ZONING AMENDMENT STAFF REPORT**Date: September 20, 2007****NAME**

LOCATION650 Palm Street
(Northeast corner of Palm Street and Cotton Street)**CITY COUNCIL
DISTRICT**

Rezoning from R-1, Single Family Residential, to B-3, Community Business District, to allow a cabinet shop.

DETAIL SITE PLAN

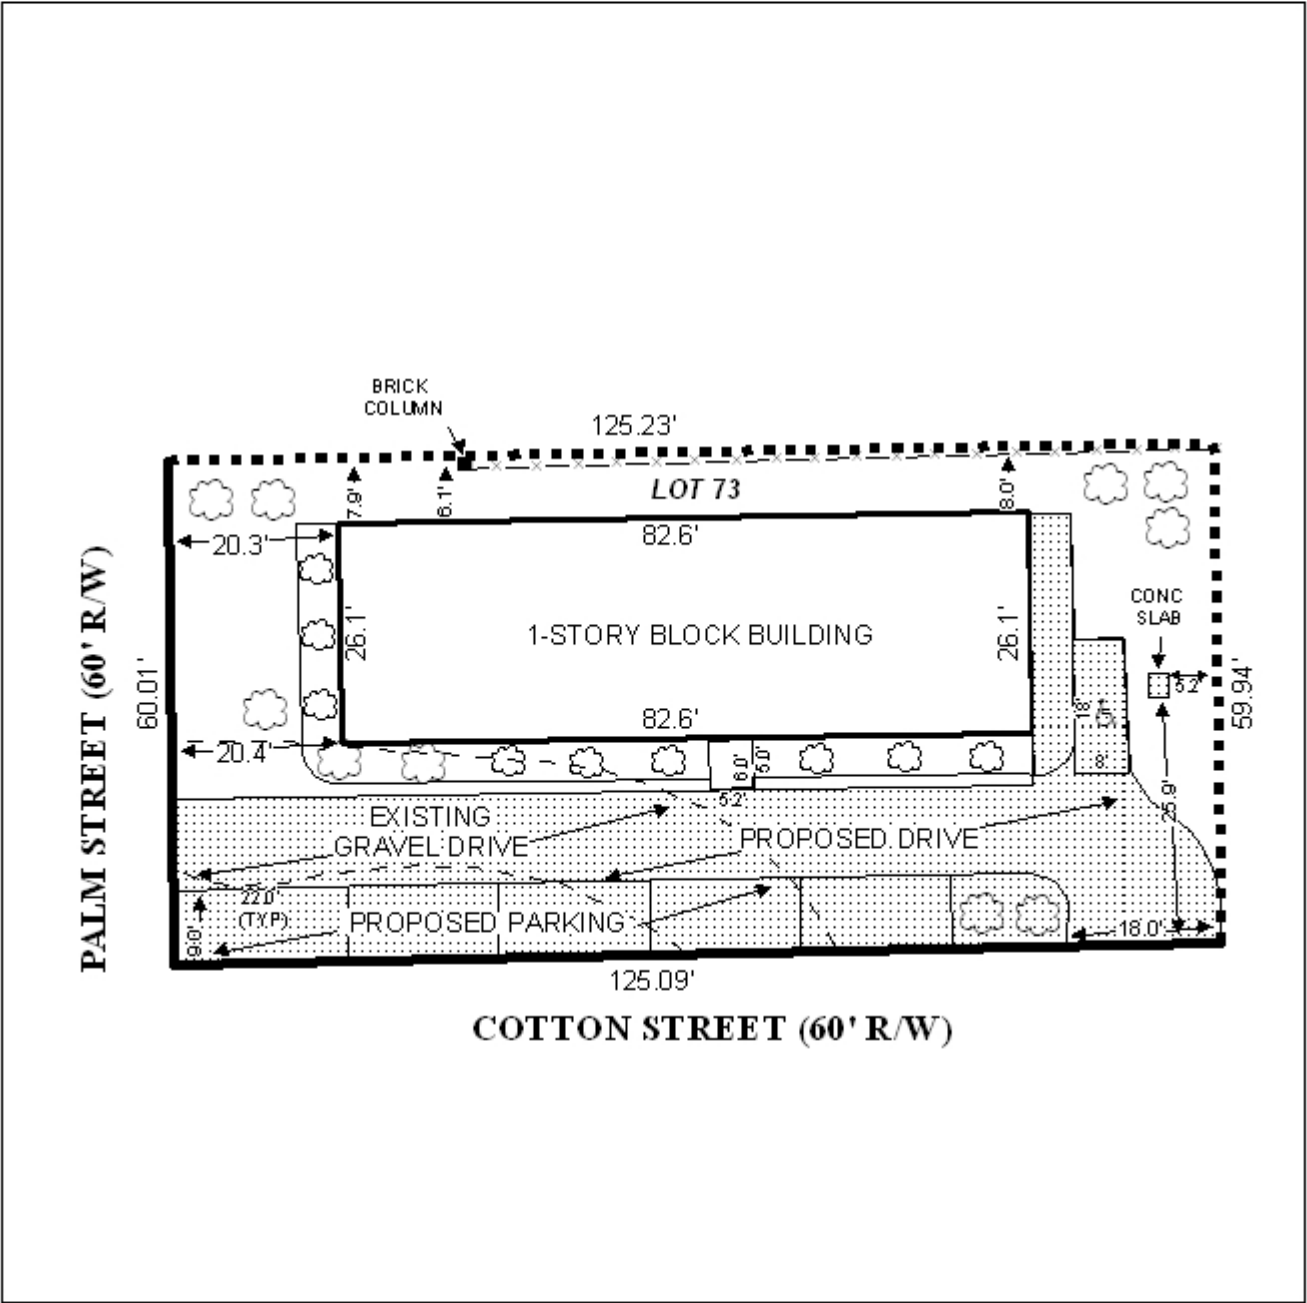
Revised for the November 15th meeting: Driveway number, size, location, and design to be approved by Traffic Engineering and conform to AASHTO standards. Minimum dimensions for parallel parking are twenty feet by eight feet as well as a minimum of a twelve foot aisle. Changes should be made to accommodate these standards. The driveway should be signed

and marked as one-way and should at least be narrowed from eighteen to sixteen feet to discourage two-way traffic flow. (Note: Traffic Engineering comments are regarding the revised October 17th site plan submitted by the applicant, not the November 7th site plan, which was submitted to Urban Development after Traffic Engineering had provided comments for the November 15th meeting – the revised site plan does not appear to fully comply with Traffic Engineer revised comments).

The site plan depicts the site improved with paved parking and access, including 3 parking spaces, an entry from Cotton Street, with one way access exiting onto Palm Street, and landscaping. The parking calculations on the site plan show that only 1 space is required for the proposed 4 employees. The existing building is approximately 2,156 square feet, however no breakdown is provided regarding how much of the building is office space versus manufacturing, warehouse, or any other use. At a minimum one could assume that 2 spaces would be required (1 space per 300 square feet of office space, plus one space per 3 warehouse employees), and up to 8 spaces could be required for a “normal” parking ratio of 1 space per 300 square feet of space (non-warehouse B-3 uses would never be able to satisfy the required parking ratio on the site). Thus more information is required to determine if parking will be adequate for the proposed use. Also, it appears that the parking stalls and maneuvering areas do not meet the minimum standards of the Zoning Ordinance.

Regarding the landscaping calculations, it appears that sufficient *area* will be available for landscaping to meet the minimum requirements of the Zoning Ordinance. The site plan does not, however, depict the actual placement of heritage and understory trees required to depict full compliance.

The site plan does not indicate the location of a dumpster or other private waste facility, thus the site plan should be revised to depict the dumpster location. The location, furthermore, should be

The proximity of a B-3 district next to residential districts will require the provision of buffering, which in this case would likely have to be a 6-foot high wooden privacy fence. The site plan should reflect the required buffering.

New development normally requires the provision of a sidewalk along the adjacent public right-of-way, therefore a sidewalk should be shown on any future site plans, should the rezoning be approved.

A revised site plan was provided by the applicant, depicting 5 parking spaces, and including tree and landscape area calculations. No breakdown was provided regarding office space versus cabinet shop work area space.

The applicant states that 1 space is required due to 4 employees. At a minimum, the Zoning Ordinance would round this up to 2 spaces for a warehouse use, with 4 employees. If one assumes that a small office, no more than 300 square feet is provided, 3 parking spaces may be required. The 5 parking spaces depicted on the site plan would exceed the number minimally required.

Regarding circulation, the site plan shows an 18-foot wide curb-cut from Cotton Street, and a 10.5-foot wide curb-cut from Palm Street. Circulation through the site would be via a 10.5-foot wide drive, which appears to be less than normal requirements (access for a fire apparatus onto the site would not be possible). It would appear that circulation must be one-way, thus the circulation route should be marked with arrows indicating the direction of travel.

The lot is approximately 7,506 square feet in size, thus at least 901 square feet of landscape area would be required. The site plan depicts 666 square feet of provided landscape area, which is 235 square feet less than is required. A variance request to reduce the landscape area below the minimum area should be submitted by the applicant, if the rezoning is approved.

Regarding trees, it appears that the site plan depicts 10 heritage trees and 9 understory trees, yet the calculations provided by the applicant states that 10 heritage and 4 understory trees would be required. Staff calculates that 6 heritage trees (total) would be required along the Cotton and Palm Street frontages, and that 6 more trees (at least half heritage) would be required due to the remaining perimeter area.

No residential adjacency buffer is depicted on the site plan, but would be required. Any buffer provided must comply with Section 64-4.D.1. of the Zoning Ordinance.

No sidewalk is depicted in the right-of-way adjacent to the site, but would be required.
